Appendix B.2

Hydrogeological Modelling Assessment and Groundwater
Modelling Conformity - Final
Golder Associates

CONFORMITY REVIEW OUTCOME FOR THE FIFTEEN MILE STREAM GOLD PROJECT ENVIRONMENTAL IMPACT STATEMENT – SECTION 6.5 GROUNDWATER QUALITY AND QUANTITY

Fifteen Mile Stream Gold Project
Hydrogeological Modelling Assessment

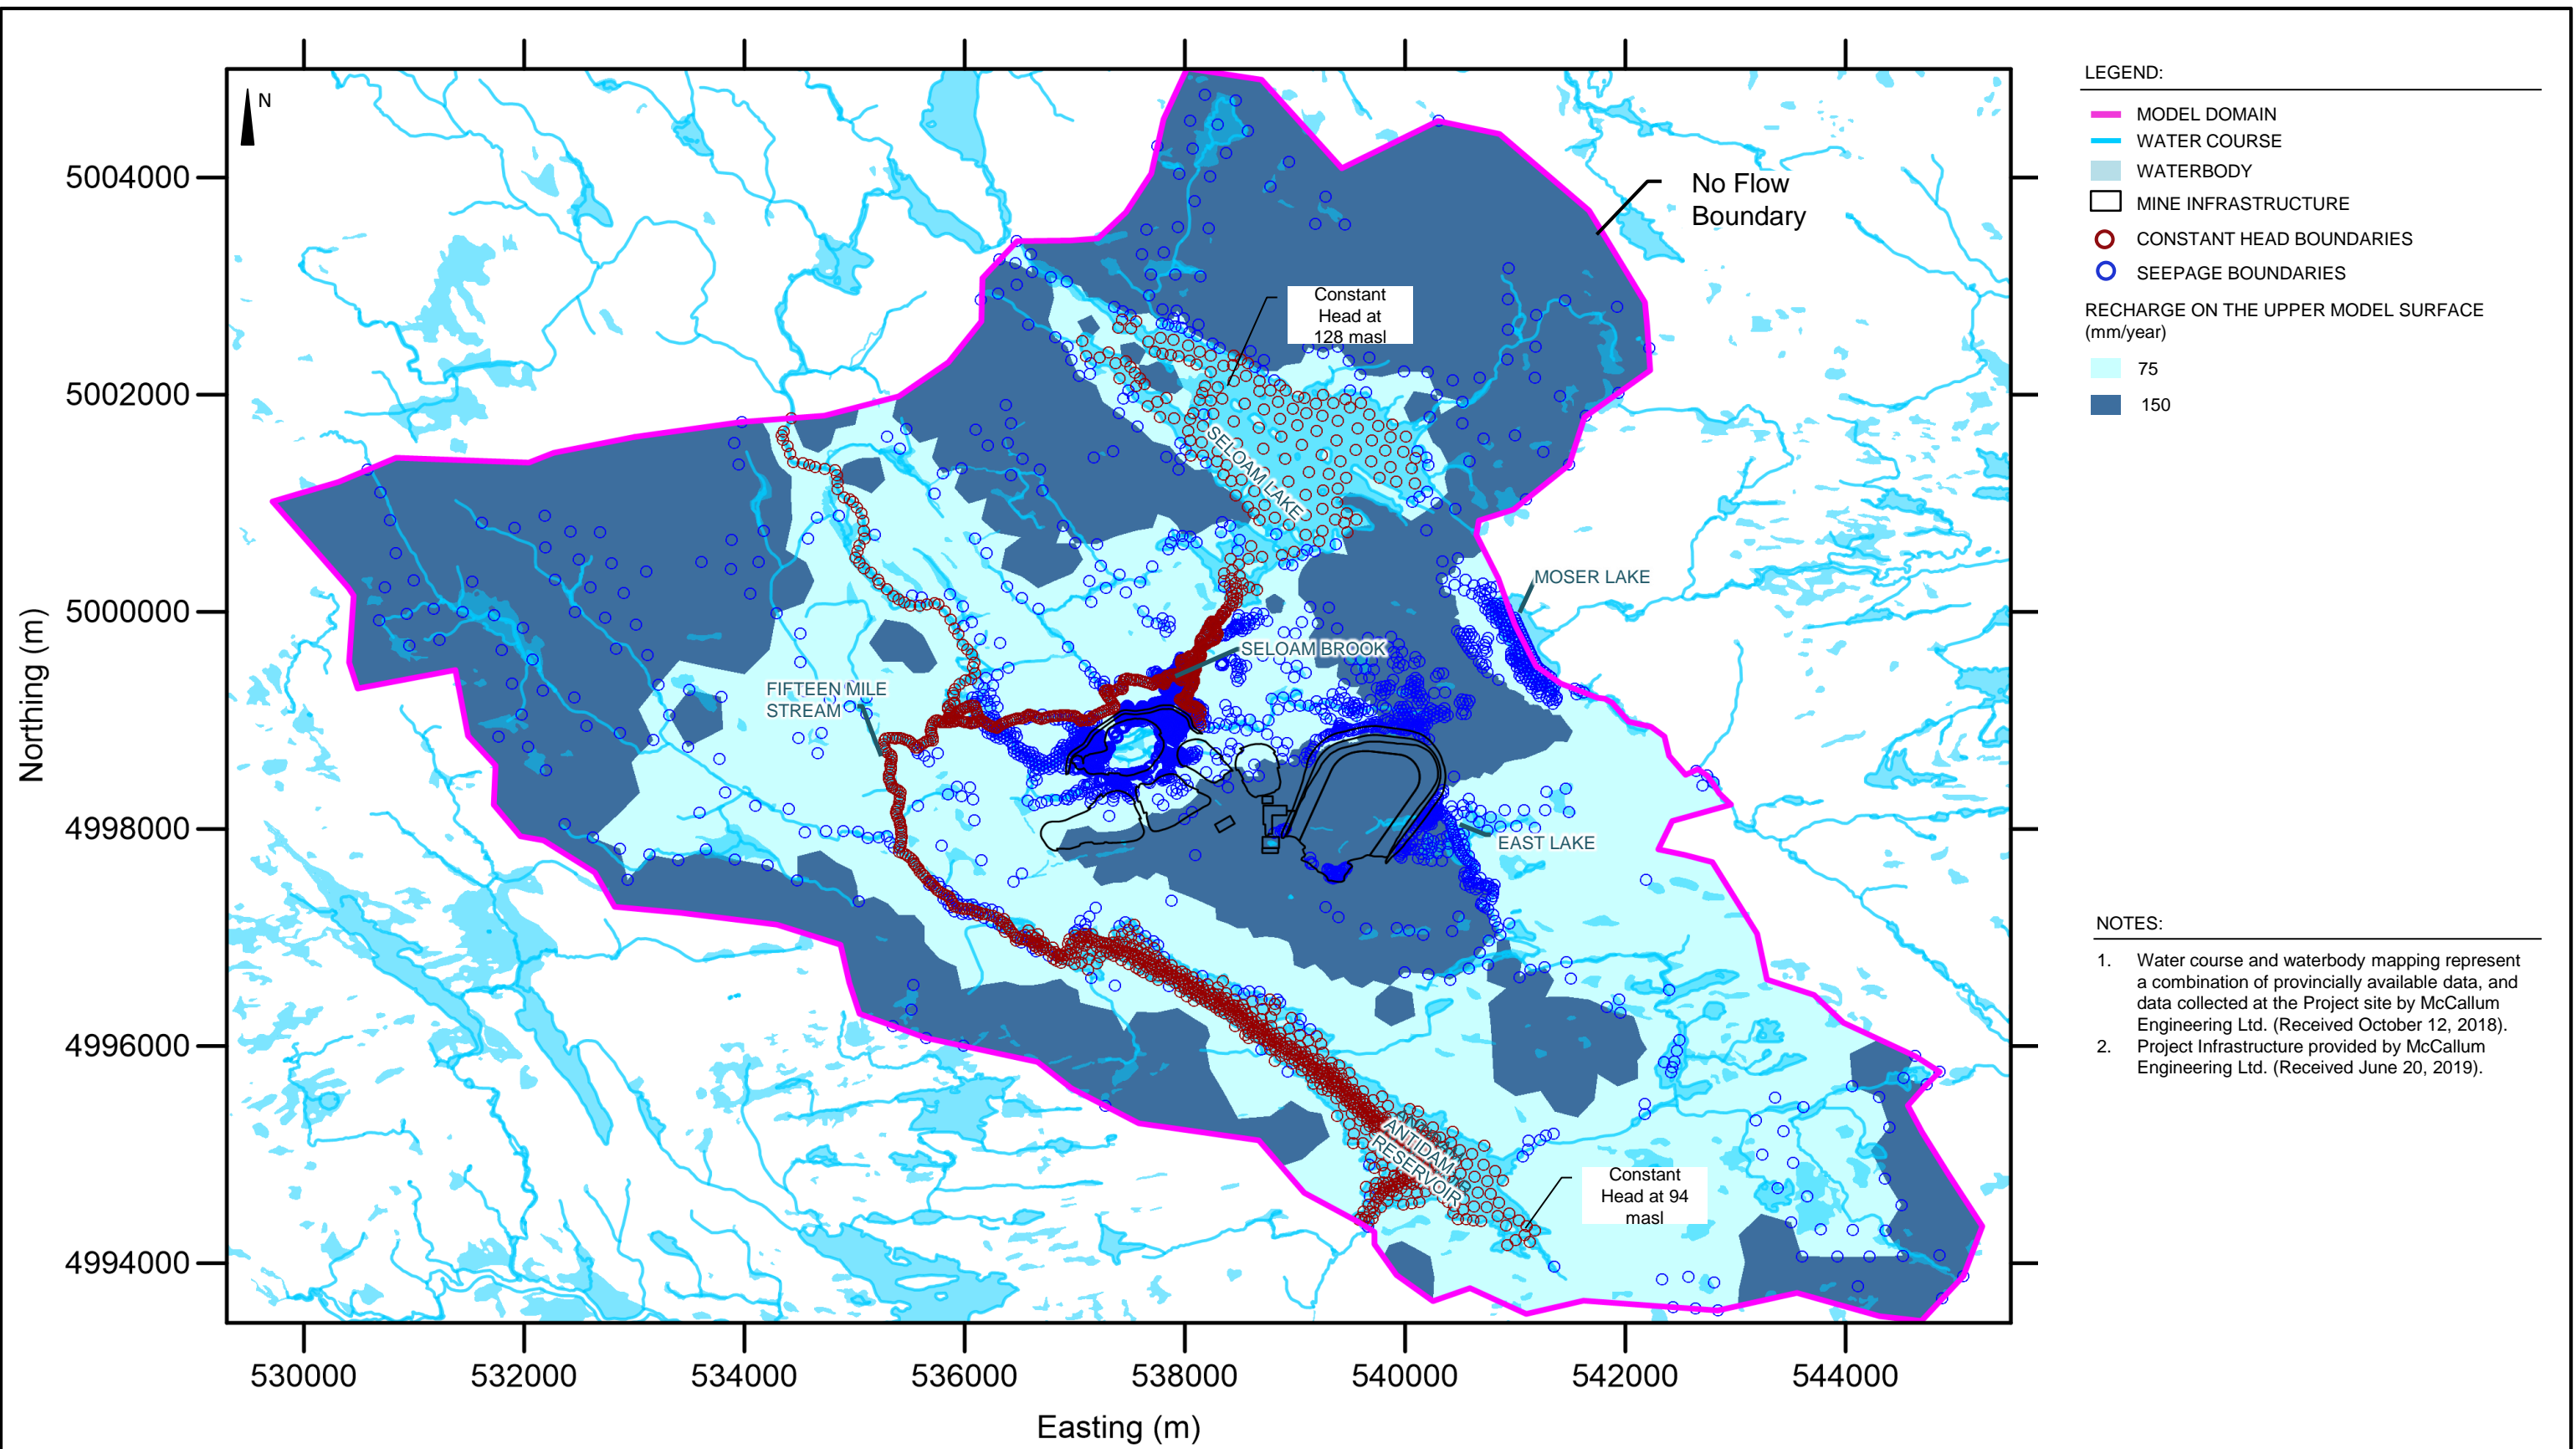
Information Requirement	Response
<p>Provide information or a sufficient rationale for the omission of the following from the hydrogeological model:</p> <ul style="list-style-type: none"> ■ The irregular model extent shape 	<p>The model extents were selected to align with hydraulic boundaries as described in Section 3.3.1 of the Hydrogeological Modelling Report, detailed as follows:</p> <p>The groundwater model domain generally aligns with the surface water sub-watershed boundaries along the eastern, western, and southern extents. The northern portion of the model domain truncates the headwaters of the Fifteen Mile Stream catchment along a topographic high. A small portion of the eastern extent of the model domain truncates the eastern portion (the headwaters) of the Moser Lake catchment.</p>
<p>Provide information or a sufficient rationale for the omission of the following from the hydrogeological model:</p> <ul style="list-style-type: none"> ■ Representative ranges of input parameters that represent the hydrogeological conditions that are then assessed in the sensitivity analysis 	<p>Details on the parameter variations used in the sensitivity analysis are detailed in Section 4.4 of the Hydrogeological Modelling Report. This includes rationale for selection of alternative recharge rates (based on the seasonal variability in groundwater elevation observations), bedrock storage (order of magnitude increase), and bedrock hydraulic conductivity (based on potential for enhanced hydraulic conductivity of the bedrock through faulting).</p>

Figure
13

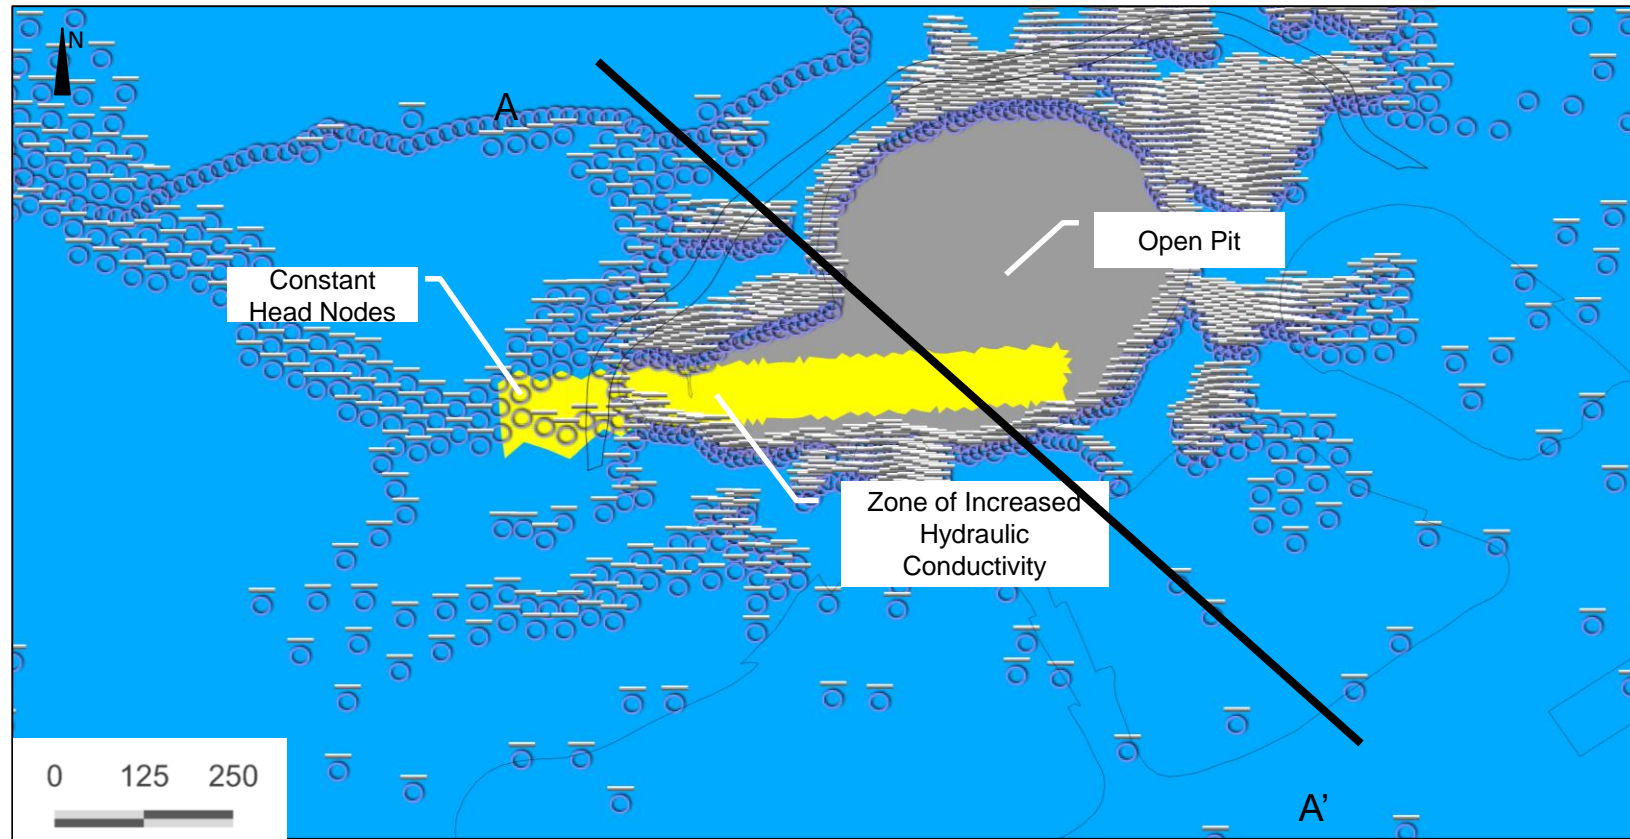
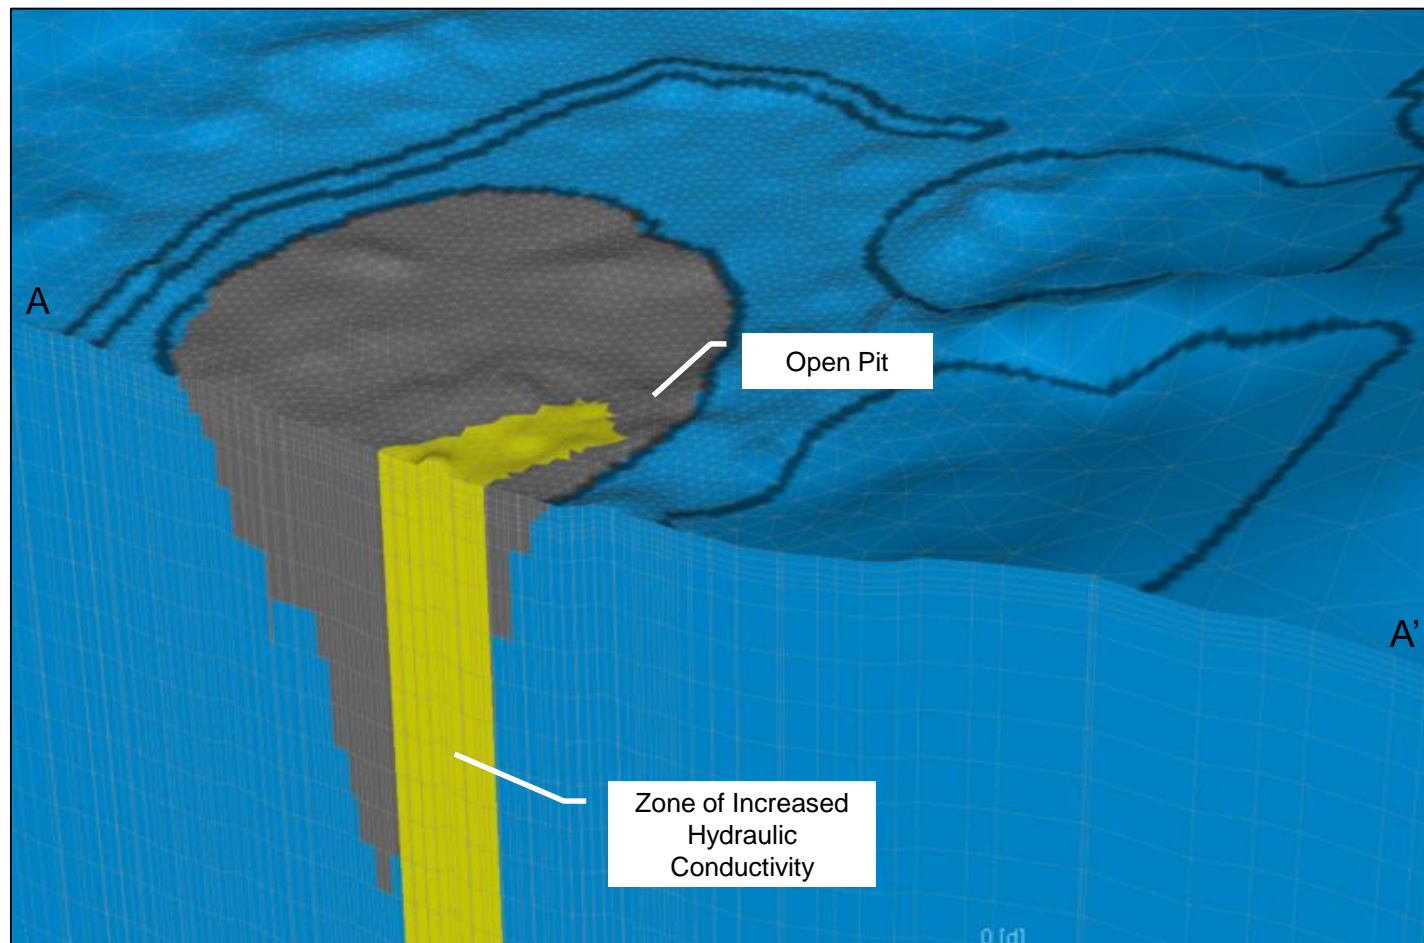
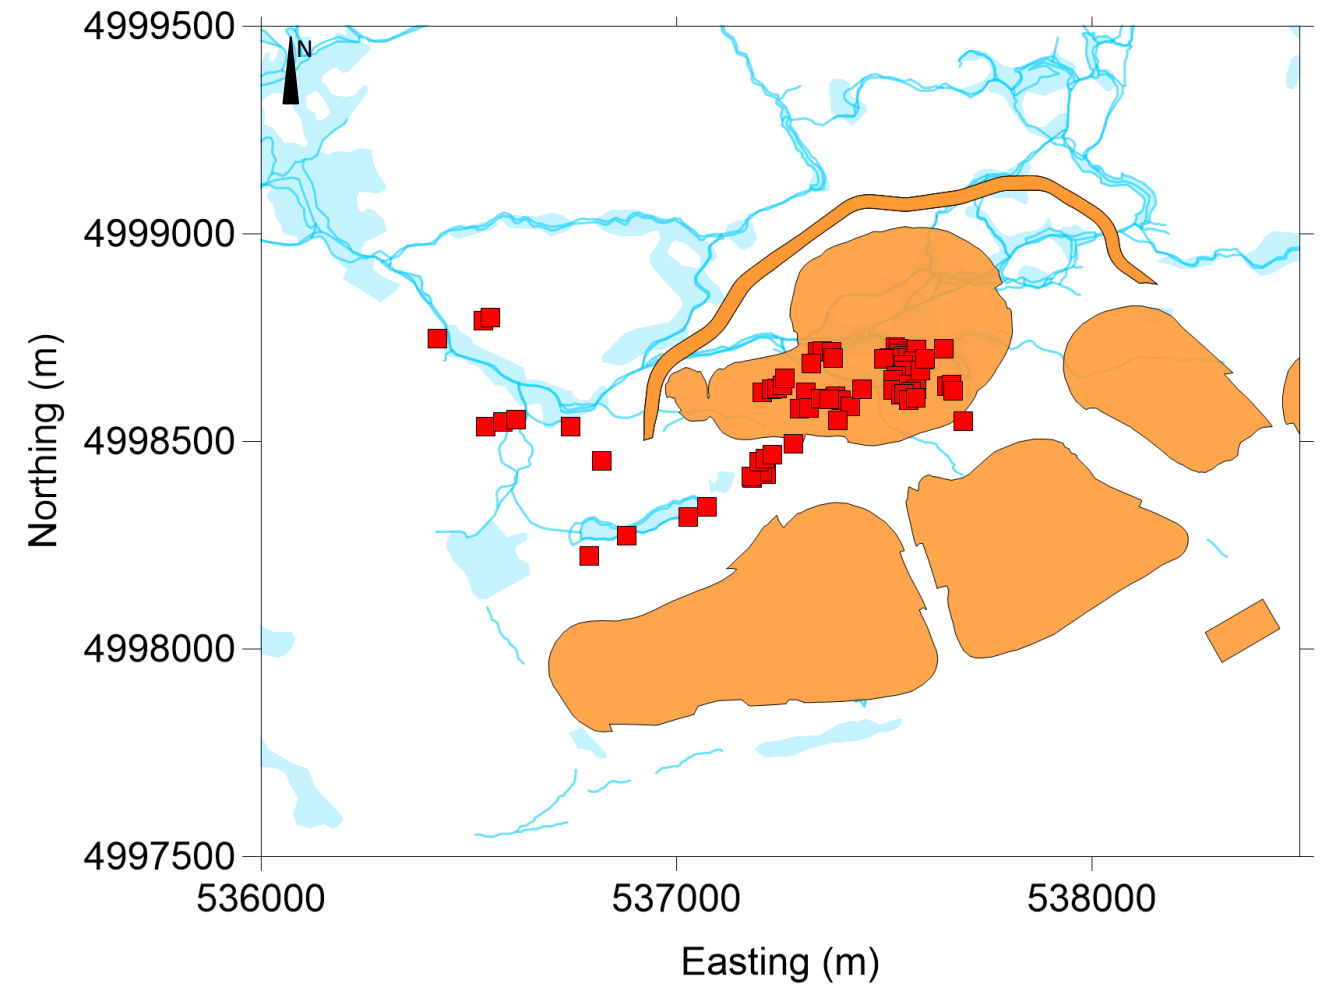
Information Requirement	Response
<p>Provide information or a sufficient rationale for the omission of the following from the hydrogeological model:</p> <ul style="list-style-type: none"> ■ Addressing the zones of “enhanced hydraulic conductivity” 	<p>Zones of enhanced hydraulic conductivity were evaluated as a part of the sensitivity analysis. The following text was provided in Section 4.4 of the Hydrogeological Modelling Assessment report: Sensitivity Run 3 (SR3) – Enhanced Hydraulic Conductivity Feature – Although not noted in field testing completed to date (See Section 2.3.2), there is the potential for bedding plans or faulting to enhance hydraulic conductivity at a local scale, providing greater potential for groundwater to flow from surface water features into the open pit. To assess the potential effect of this flow on groundwater inflows to the open pit a 100-metre-wide zone of enhanced hydraulic conductivity was added to the model to better connect the open pit area to surface water sources (i.e., Seloam Brook) west of the pit. The configuration of this zone is shown on Figure 13. Within this zone the horizontal and vertical bedrock hydraulic conductivity, as well as the overburden hydraulic conductivity, was increased by a factor of 10. The inclusion of this enhanced zone of hydraulic conductivity increased the groundwater inflow to the open pit to 690 m³/day (25 percent higher than the base case estimate).</p>
